ADDENDUM NO. 3
TO GENERAL, MECHANICAL AND ELECTRICAL
ABERDEEN PUBLIC WORKS
MAINTENANCE BUILDING
ABERDEEN, SOUTH DAKOTA

Addendum Dated: March 23, 2026

Original Plans and Specifications Dated: February 20, 2026

1 FIRST FLOOR - AREA D & MEZZANINE - AREA B - FIRE PROTECTION PLAN
1/8" = 1'-0"

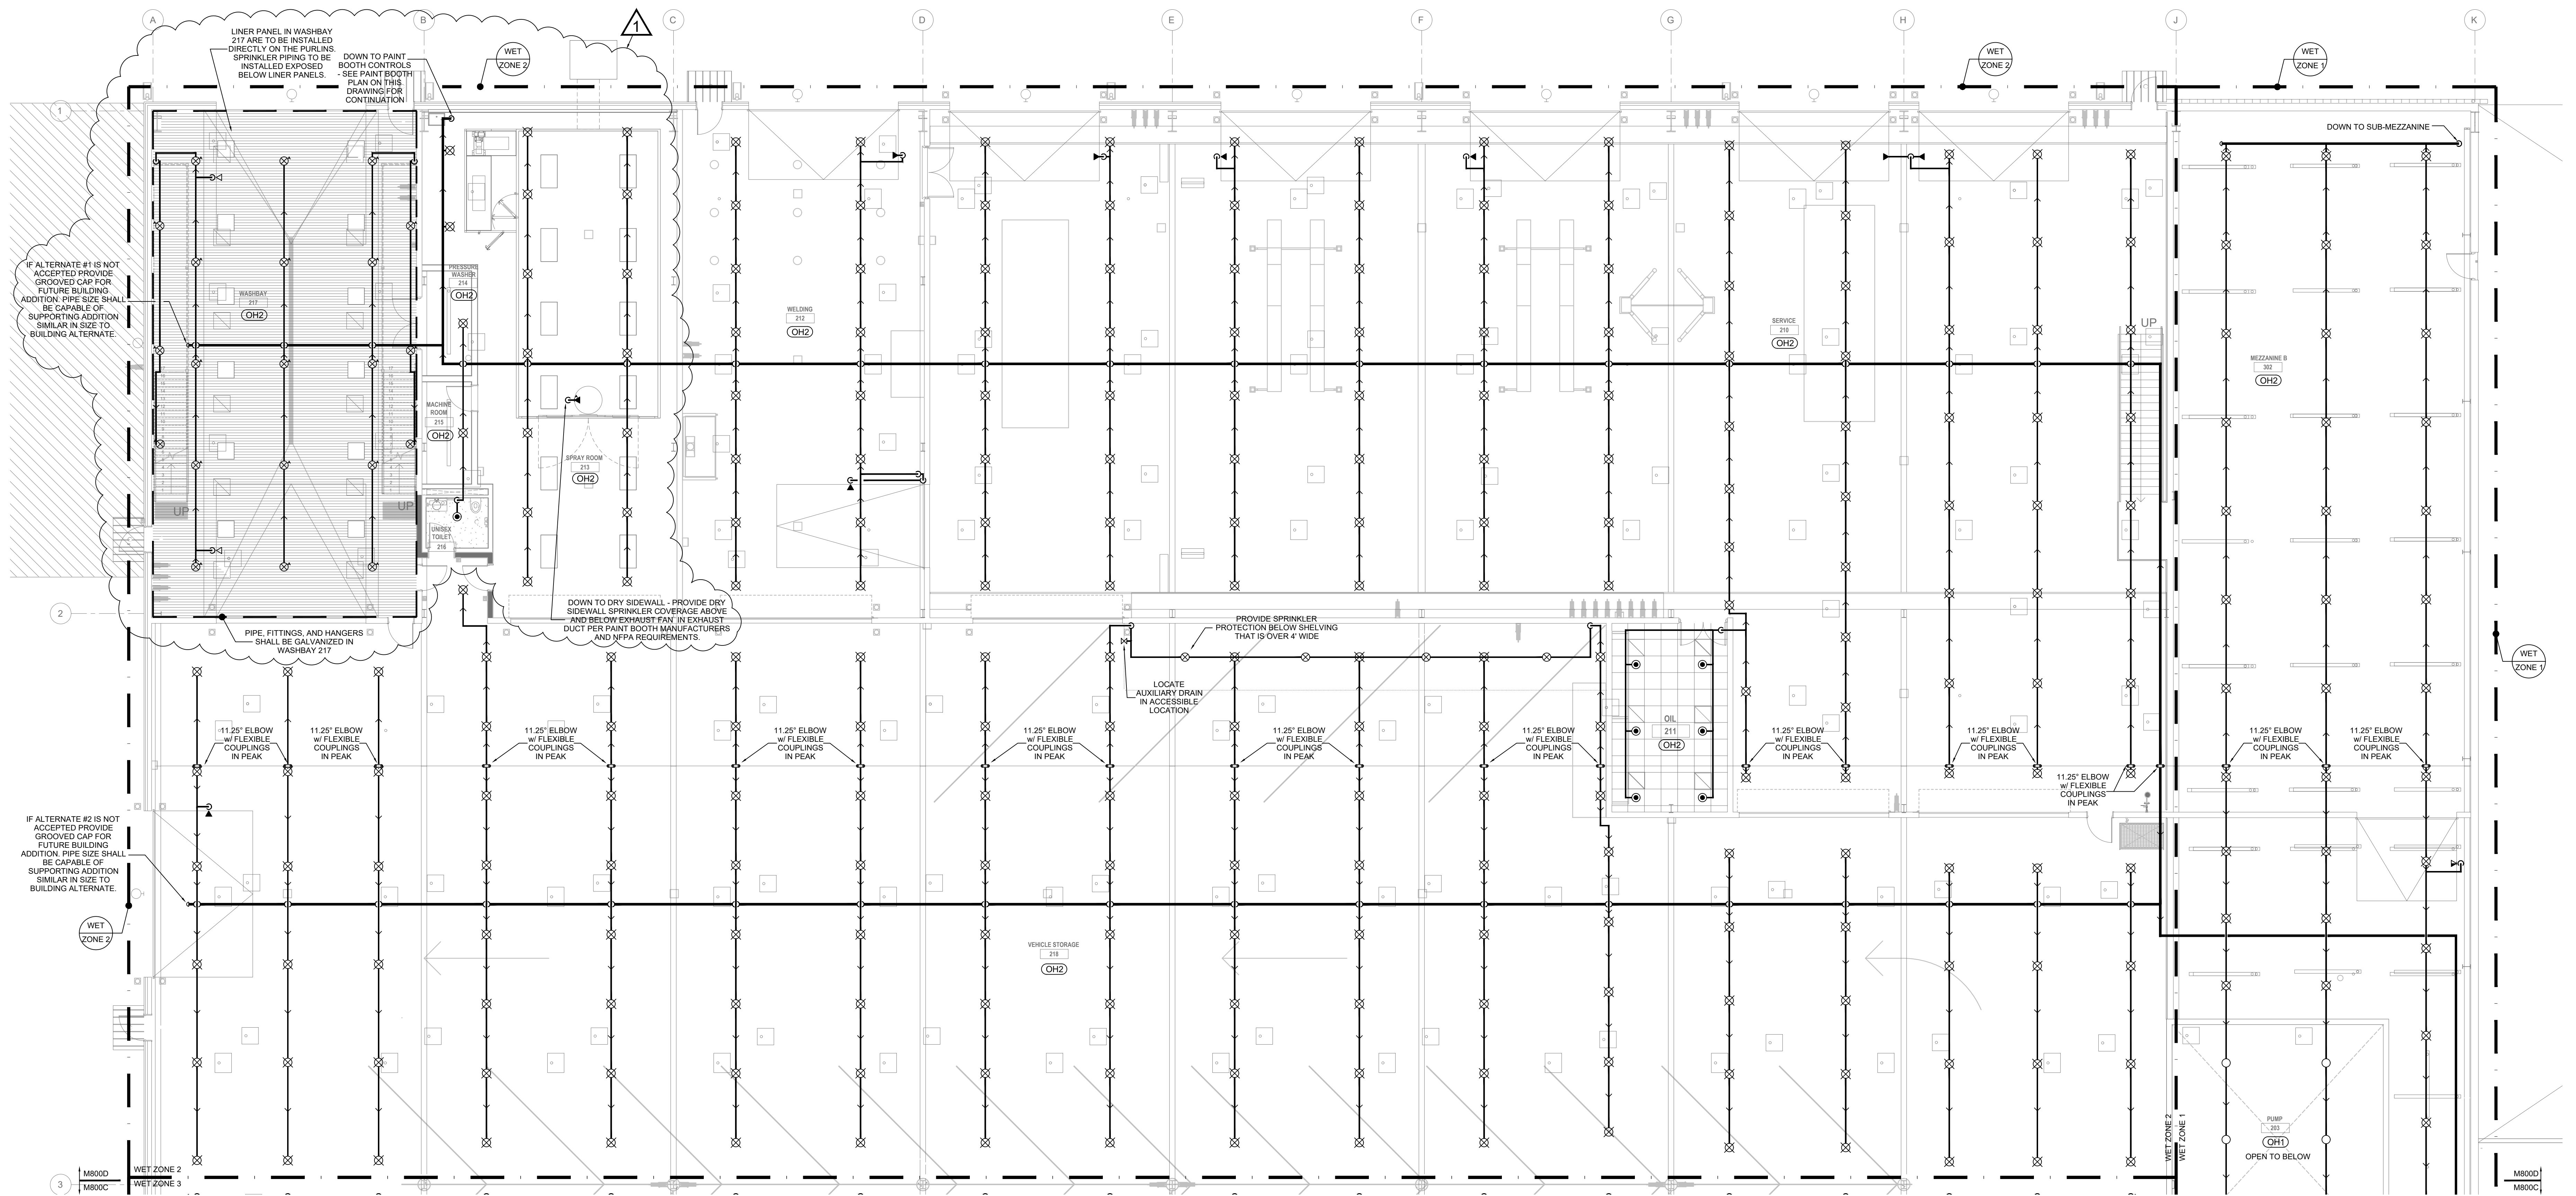
- 1. See attached sheet for the following revisions:
 - a. Fire sprinkler piping updated in Washbay 217 and Spray Room 213 area.

1 FIRST FLOOR POWER PLAN - AREA B
1/8" = 1'-0"

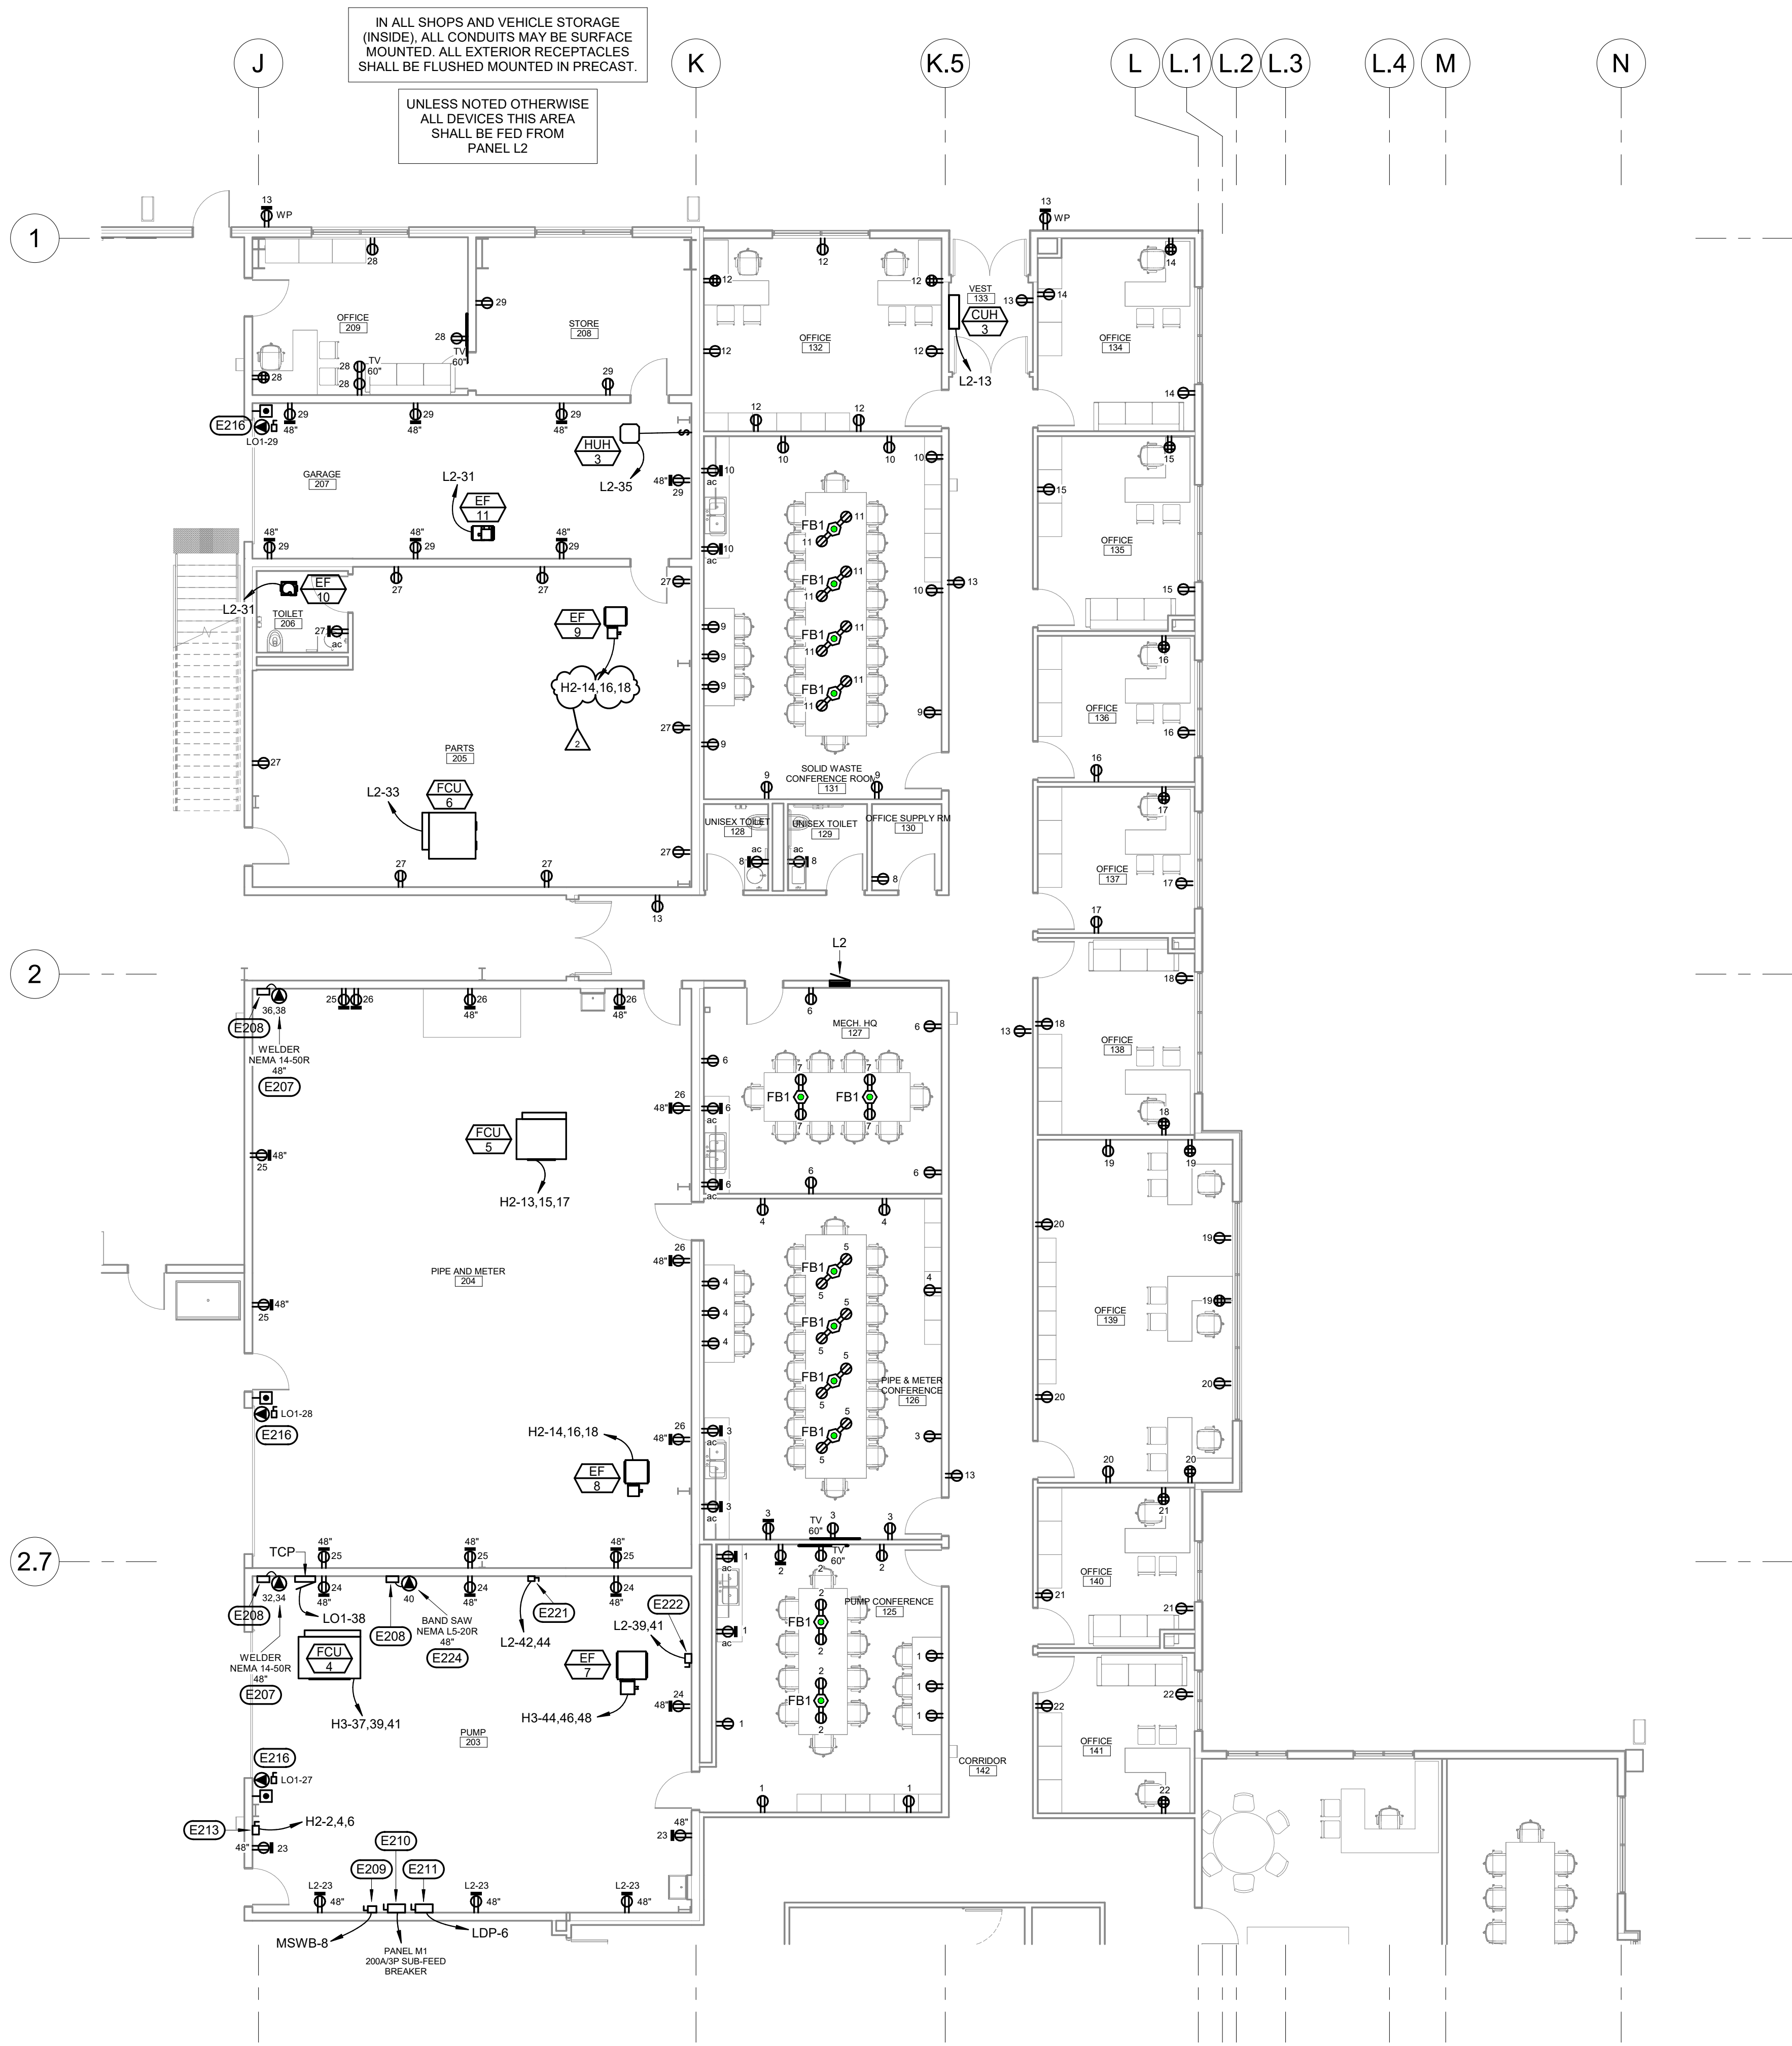
- 1. See attached sheet for the following revisions:
 - a. Revised circuiting for EF-9.
